Proposed Corriegarth 2 Wind Farm: Response to SEPA Consultation Request

Appendix A – Amended Figures

Corriegarth 2 Wind Farm

Outline Peat Management Plan

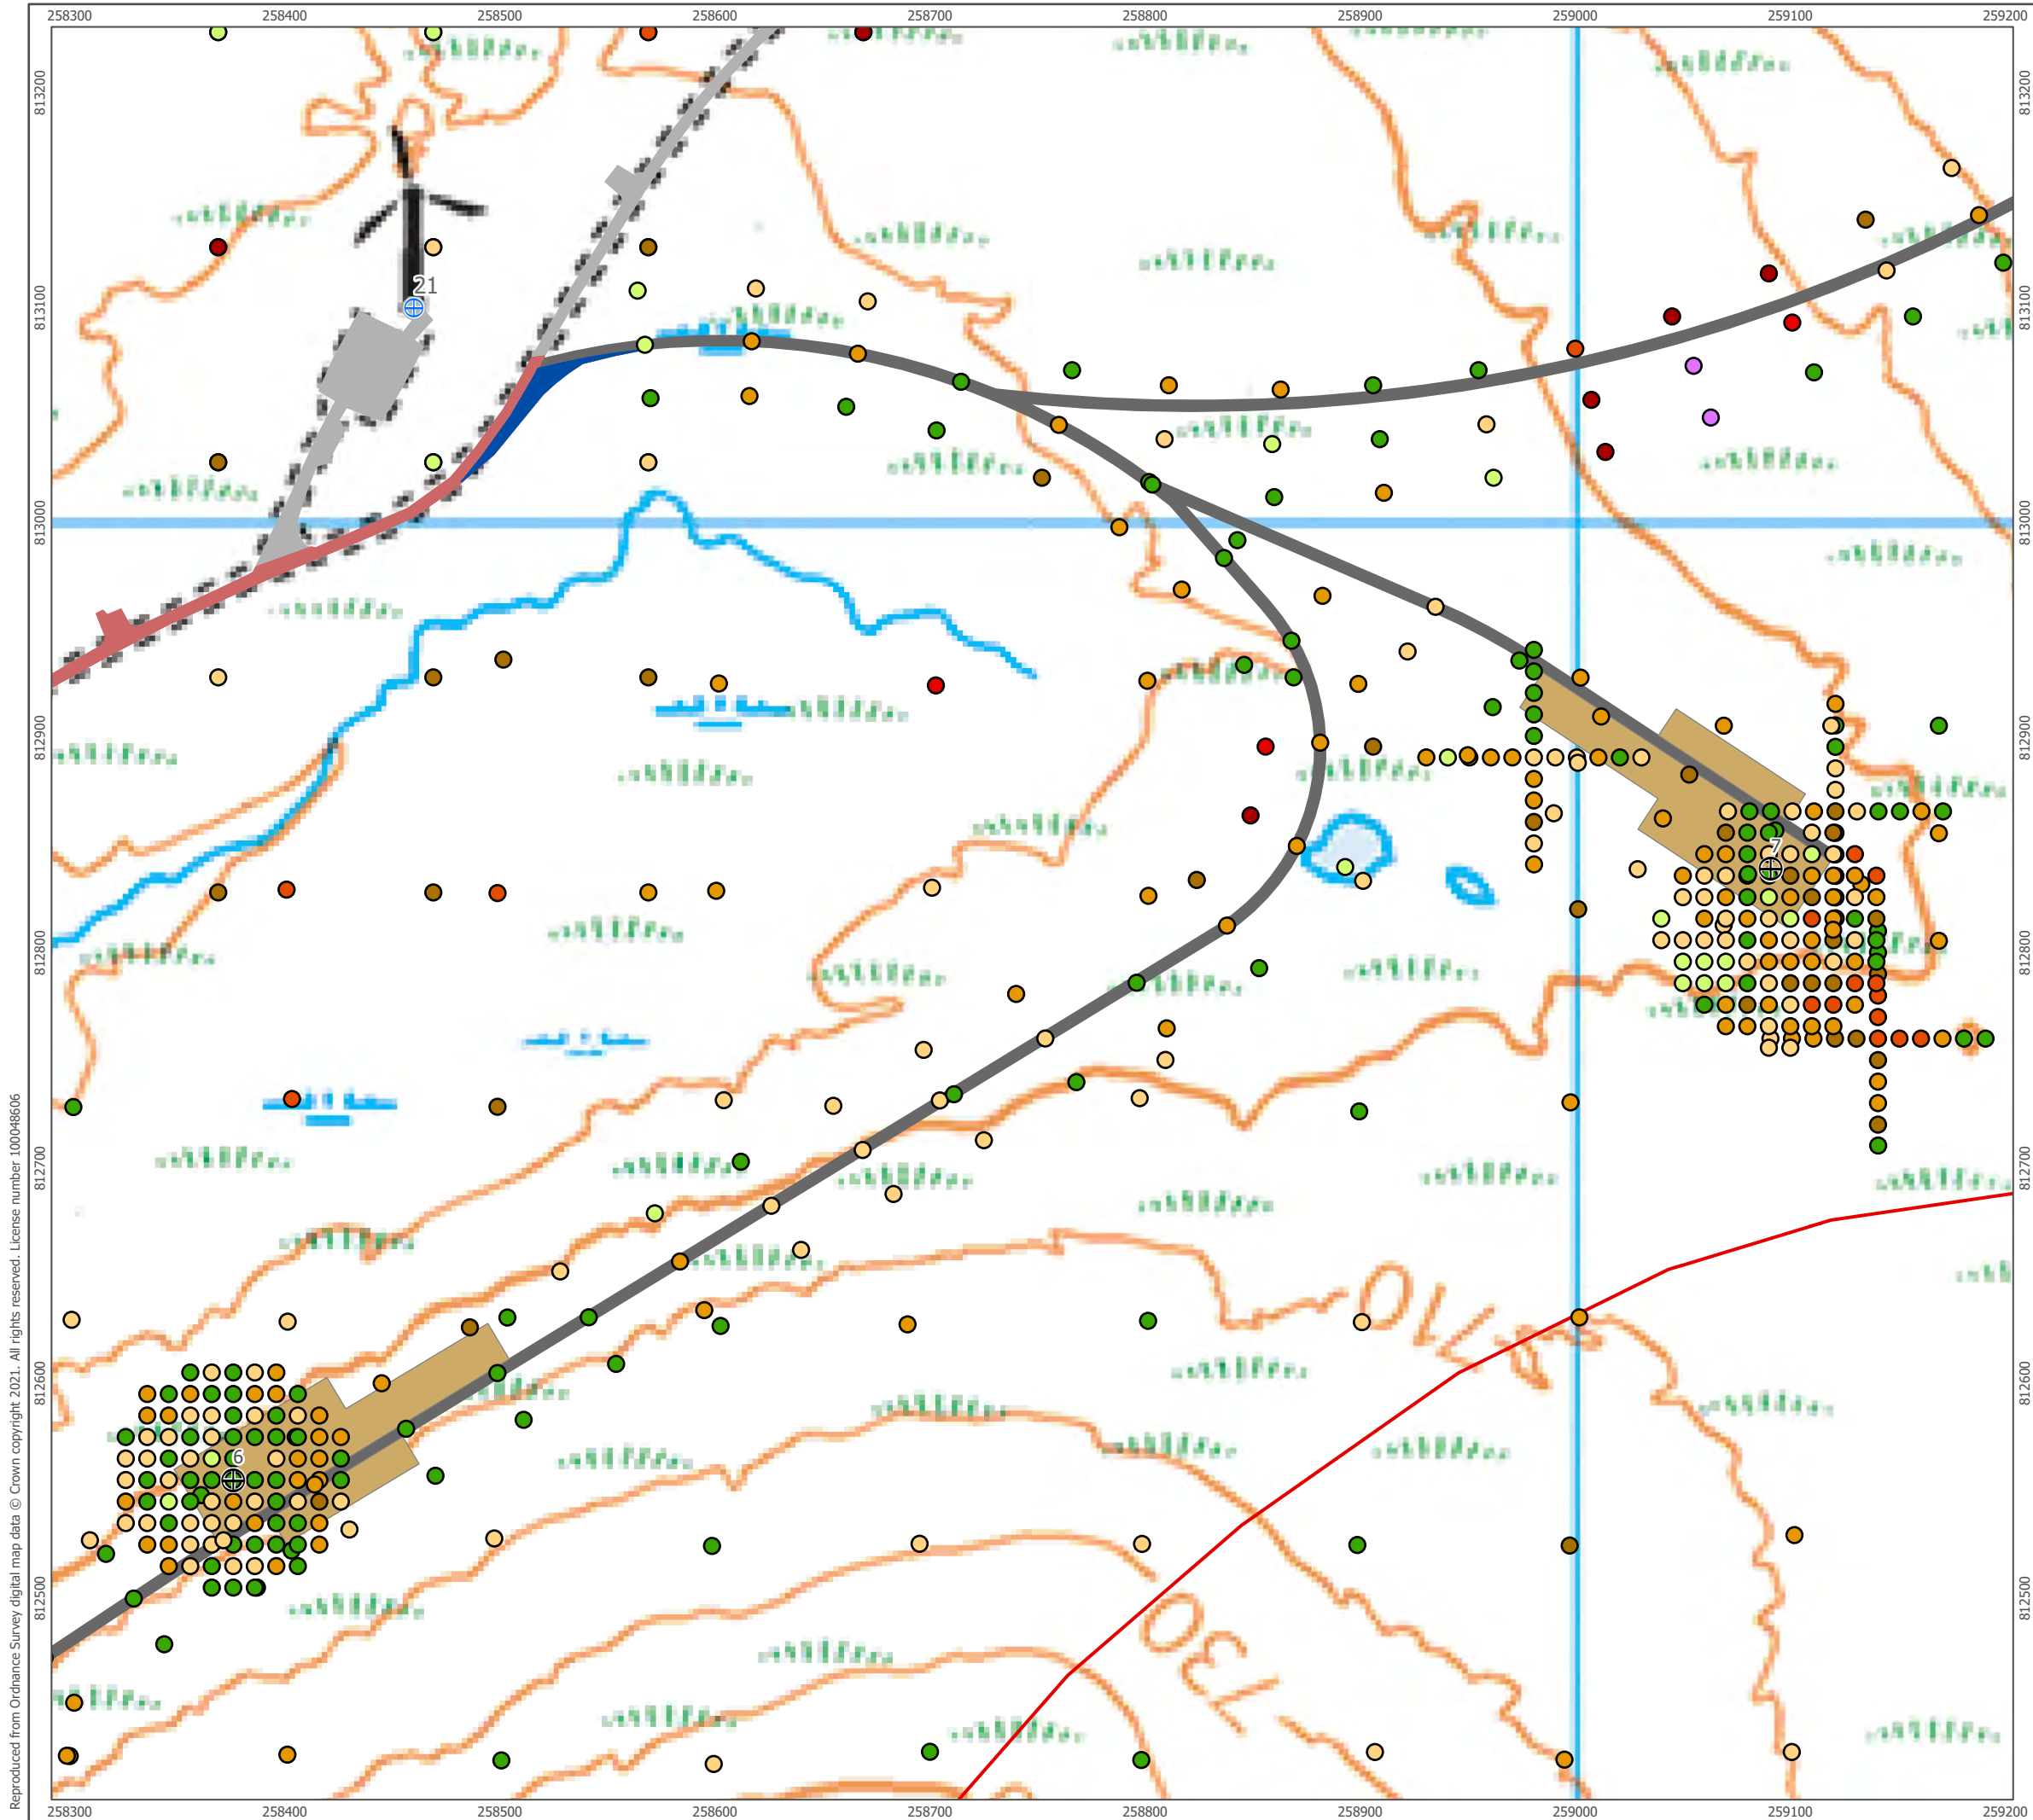
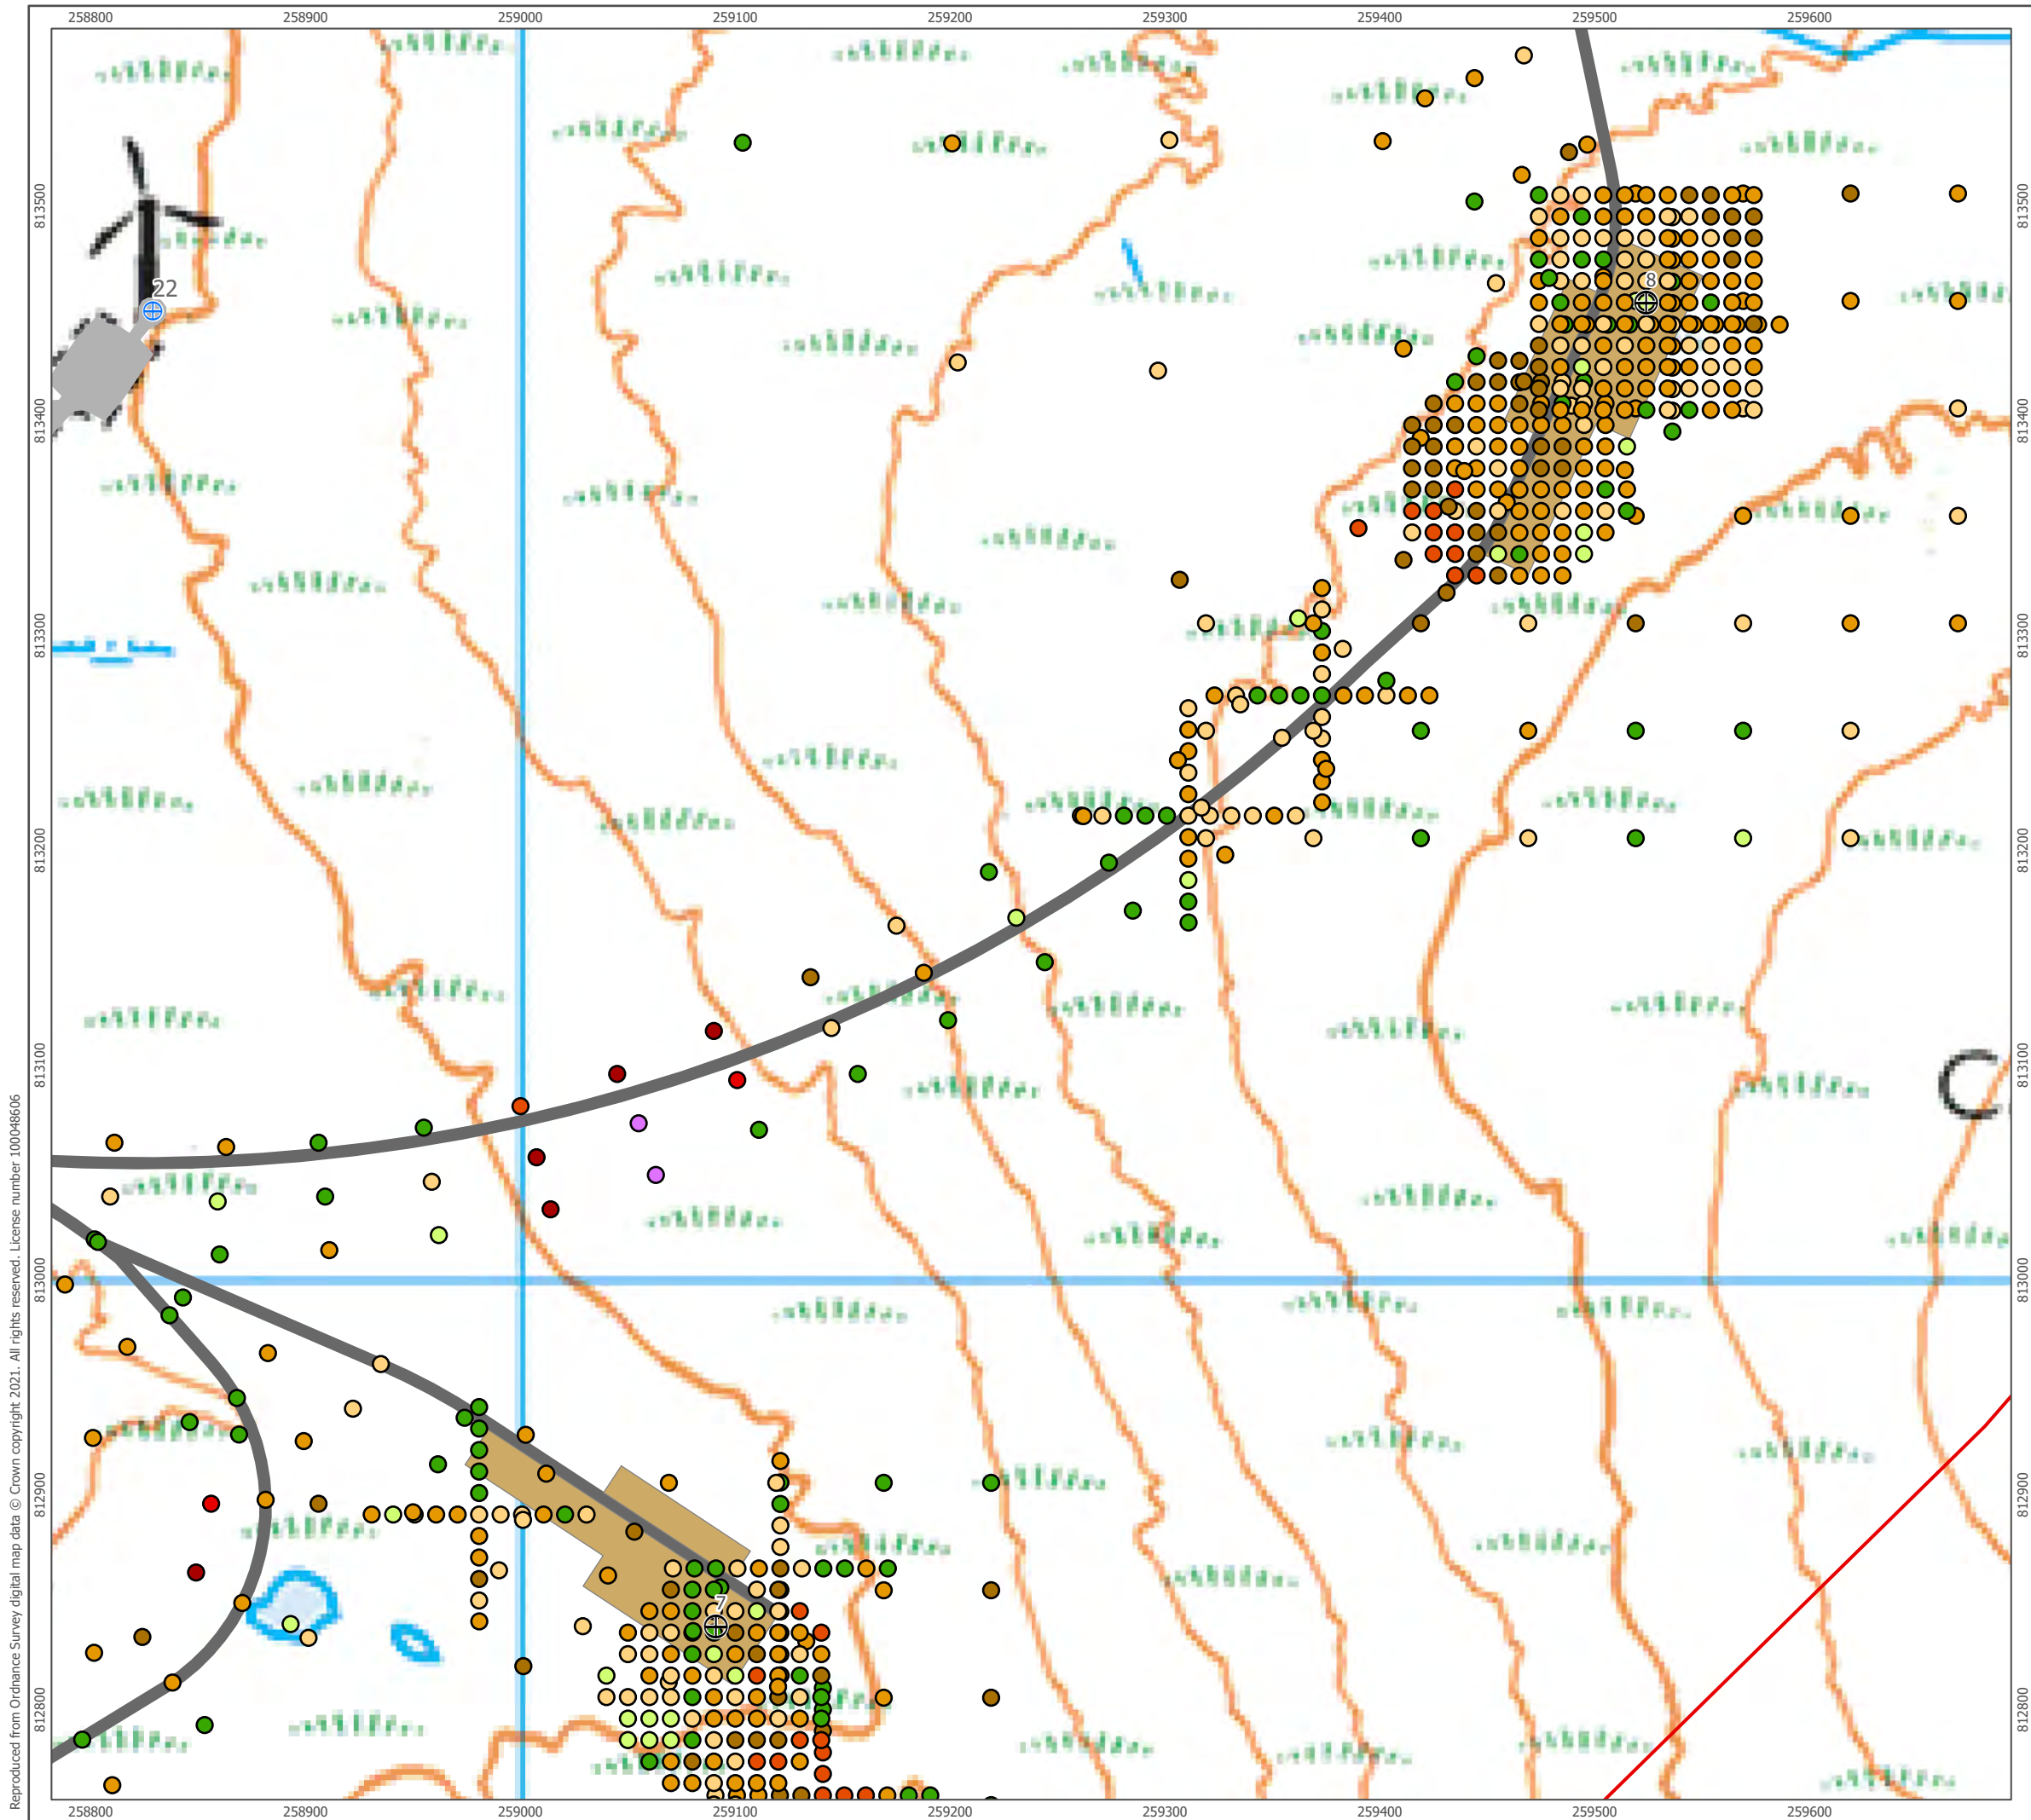
1. Figure 7.2 of Chapter 7: Ecology of the EIA Report is amended to include all proposed infrastructure associated with the Development (clearly marked);
2. All of the figures contained within Technical Appendix A7.1: Habitats and Botany Surveys to include all proposed infrastructure associated with the Development (clearly marked); and
3. Figure 13.2.2 of Technical Appendix A13.2: Outline Peat Management Plan to be provided on OS Basemapping; to be provided in a map series format; and with a revised symbology colour ramp.

3.	Figure 13.2.2 has been amended to include 25k OS Basemapping, as requested. Additionally, the figure is now spread over several maps providing a more appropriate scale for the reader to understand the peat probe depths more accurately in relation to infrastructure. A revised colour ramp has also been provided.
